**MITIGATION PLAN  
FINAL**

**Mill Dam Creek Restoration Site  
Yadkin County, North Carolina  
DMS Project Number 97136  
DEQ Contract 6898  
SAW-2016-01335**

Subject: Mill Dam Creek Restoration Site  
Mitigation Plan Review – Response to IRT Comments  
Yadkin River Basin - 03040101  
Yadkin County, North Carolina  
DEQ Contract No. #6898  
DMS Project #97136  
USACE AID #: SAW-2016-01335

**Figure 10. Proposed Monitoring, Mill Dam Creek, Yadkin County, NC**

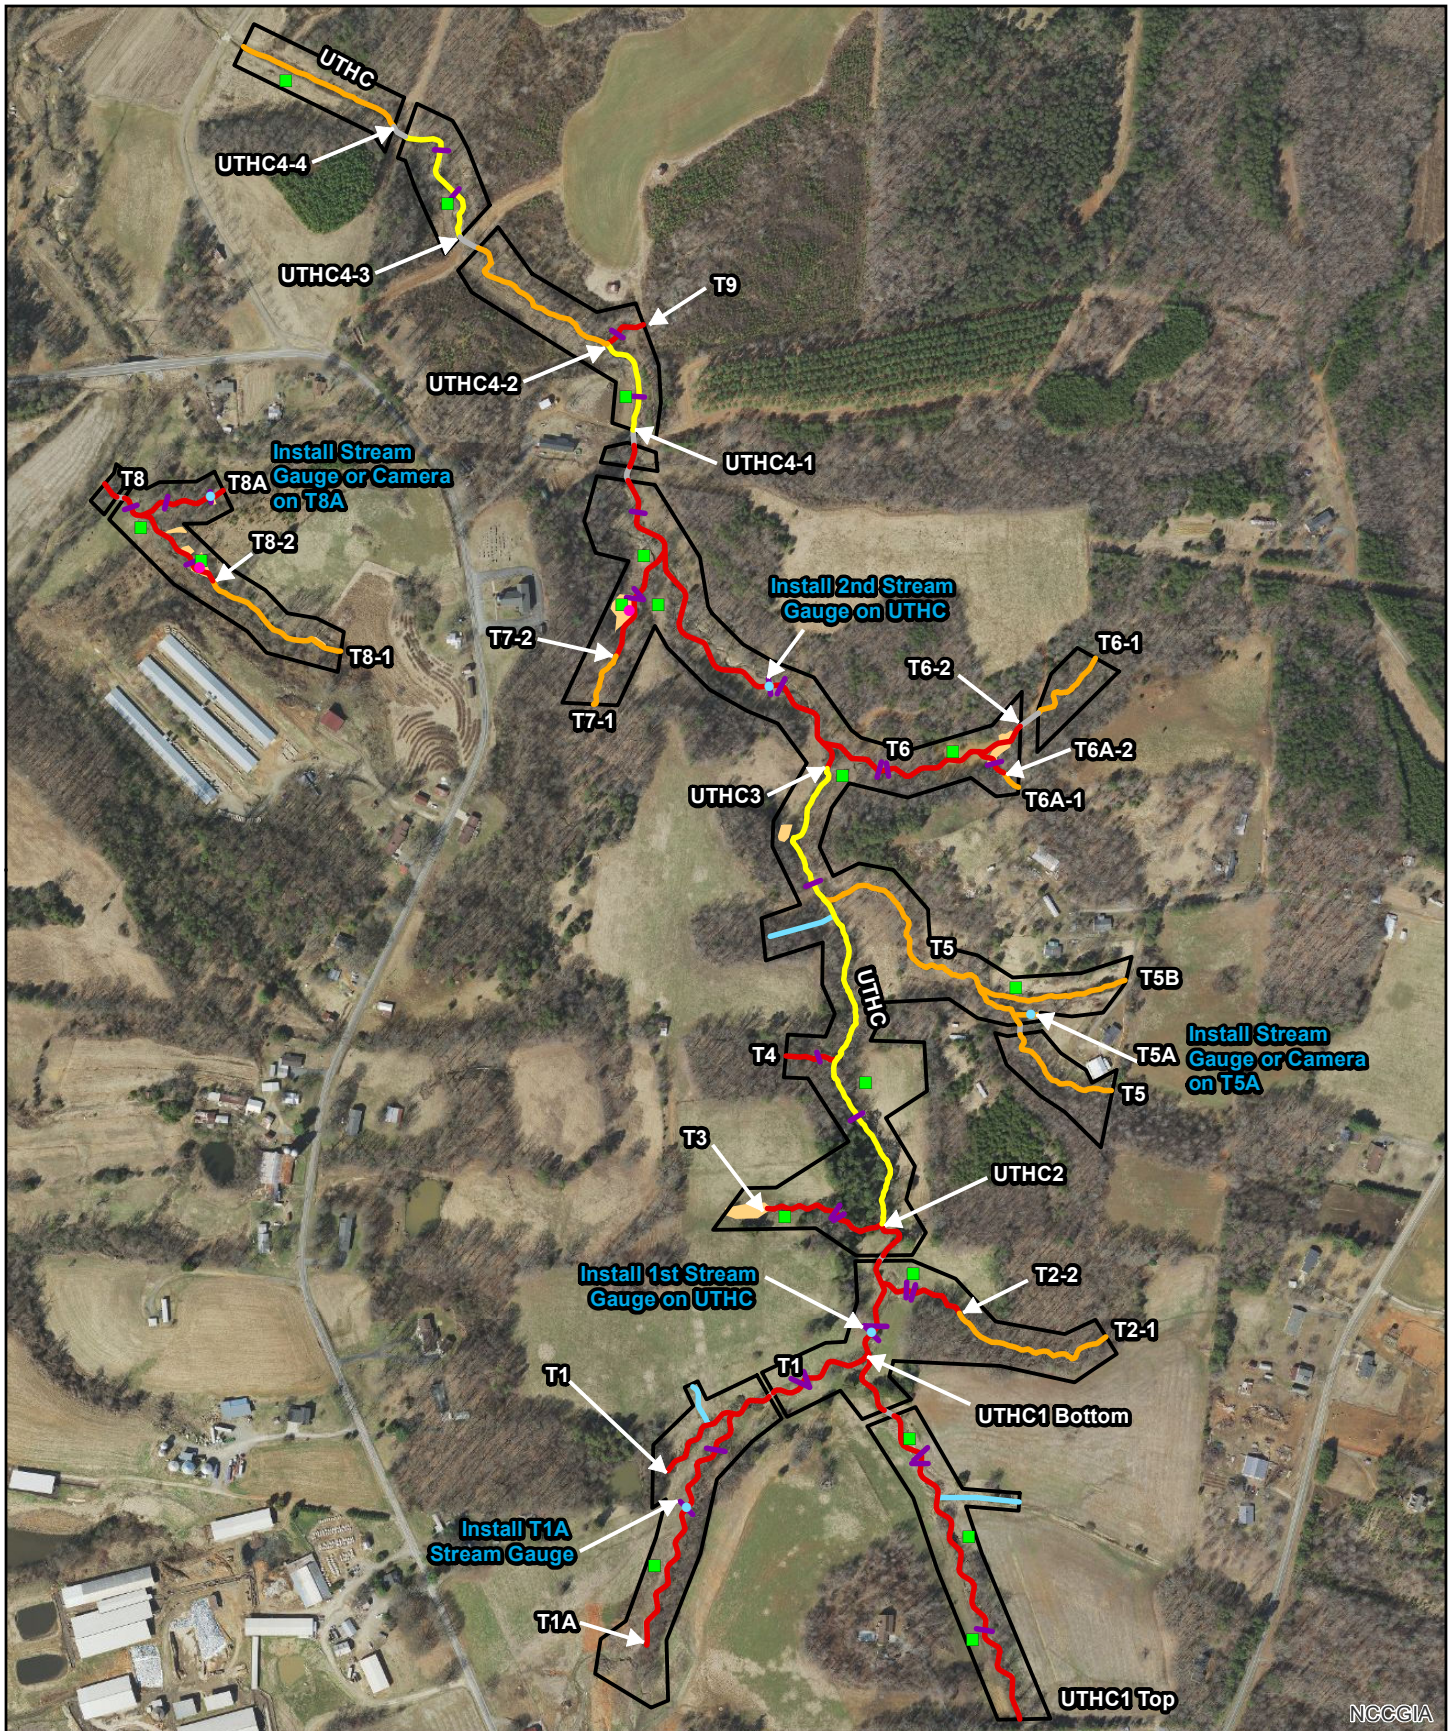
- ***We have added stream gauge and/or camera monitoring to T5A and T8A in both the mitigation plan text and on Figure 10.***
6. Section 7.0 Performance Standards- states that “project streams must also show a minimum of 30 days of continuous flow...” Please realize this standard was developed initially for coastal headwater systems. The standard is currently being applied to intermittent streams statewide. While the IRT is currently reviewing this standard for intermittent streams outside the coastal plain, the 30-day flow metric does not apply to perennial streams.

5. Section 6.7: Please include a description of the planned pond dam removal, as well as the proposed pond bed sediment removal.
  - **We have added further description of the removal in Section 6.7 – please see the revised mitigation plan.**
6. Section 8.0: Vegetation Monitoring—Veg plots should be added to the areas with existing wetlands, particularly along T7 and in the area where the pond bed currently is.
  - ***We have converted three of the planned randomly placed plots to permanent plots within former pond along T6, Wetland WA along T7, and Wetland WH along T8. See revised Figure 10. Proposed Monitoring Map.***
